# IEEE 802.3 Interpretations Report

March 16th, 2004  
Atlanta, GA  
David Law  
David\_Law@3Com.com

**Interpretation Number:** 1-03/05  
**Topic:** Discovery Handshake Message Exchange  
**Relevant Clause:** Figure 64-14  
**Classification:**

Figure 53–2—Block diagram for LX4 PMD transmit/receive paths

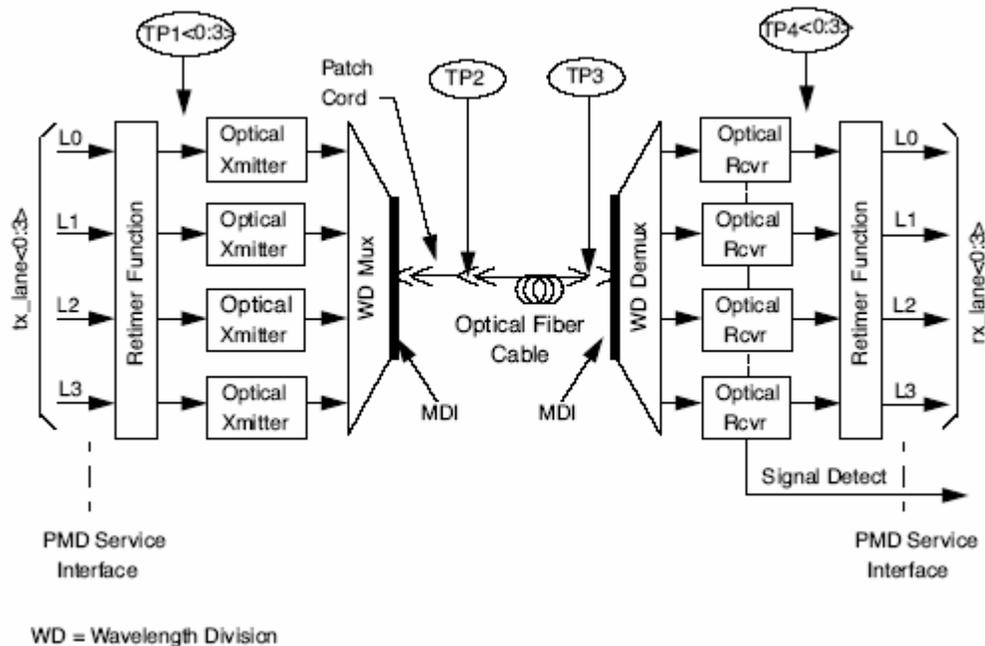
With respect to Fig. 44A-5 and Fig. 44A-6 it is now unclear if this specification can be applied to the transponders PMD side as well, and if, how the values given in Table 48-5 would then be translated to the Test-Point (TP) terminology that is used in clause 53.1. In detail, a clear statement what the allowed skew values at TP[1:4] (ref. to Fig. 53.2 of clause 53.4.1) are is missing.

Per Table 48-5, allowed skew at TP2 is 3 UI. The medium is allocated 18 UI, giving an allowed skew at TP3 of 21 UI. TP1 and TP4, shown in Figure 53-2, are provided for reference only. The specification of performance at TP1 and TP4 is implementation specific.

Figure 57-5—OAM Discovery state diagram

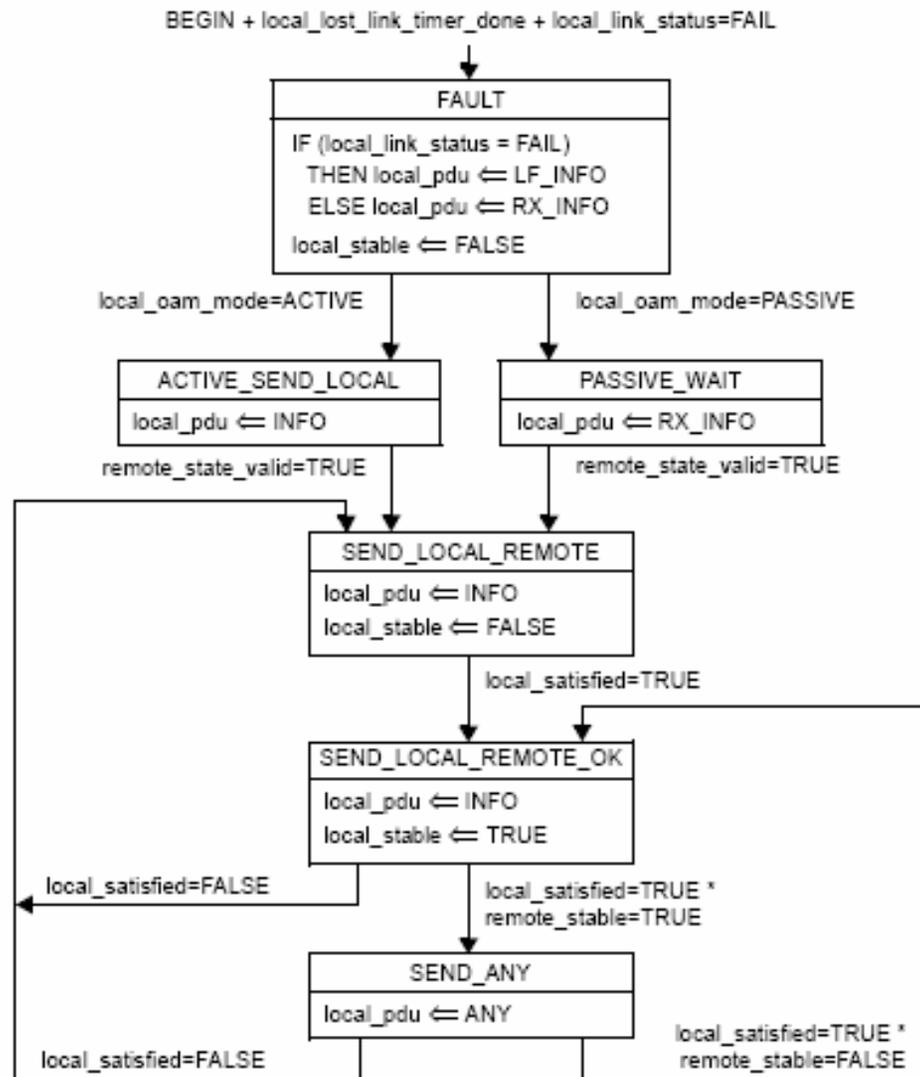
When `local_lost_link_timer_done` is true an OAM capable device is required to return to the FAULT state. Due to the nature of this global transition, the device will remain in this state until the `local_lost_link_timer` is restarted. However `local_lost_link_timer` is restarted only on the reception of an OAMPDU. This presents an issue because the reason the device is in the FAULT state to begin with is that it had not received an OAMPDU from its remote partner for 5 seconds. So now the device remains stuck in the FAULT state.

Once the device is stuck in the FAULT state, it can no longer transmit OAMPDUs thanks to the “ELSE `local_pdu <= RX_INFO`” statement. The remote OAM device will similarly fall into the FAULT state because its `local_lost_link_timer_done` will become true after 5 seconds. Now both devices are trapped in the FAULT state with no ability to escape because neither is allowed to transmit an OAMPDU.

Is this interpretation correct? Or does `local_lost_link_timer` automatically reset itself once `local_lost_link_timer_done` is true. If it doesn't it would seem to me that if `local_lost_link_timer` was somehow reset after its expiration (perhaps in the FAULT state) that the issue would cease to exist. The device would then have 5 seconds to drop into the `ACTIVE_SEND_LOCAL` or `PASSIVE_WAIT` state and attempt to reestablish a connection with the remote device before falling into the FAULT state again.

The local\_lost\_link\_timer is reset only upon reception of an RxOAMPDU as shown in Figure 57-8 so once the local\_lost\_link\_timer\_done signal sets it stays set until an RxOAMPDU is received. Meanwhile, the state diagram in Figure 57-5 is held in the FAULT state "due to the nature of this global transition" where, because local\_link\_status is not equal to FAIL, no TxOAMPDUs get transmitted.

Concerns have been raised about this issue that are being considered in the IEEE P802.3REVam revision.
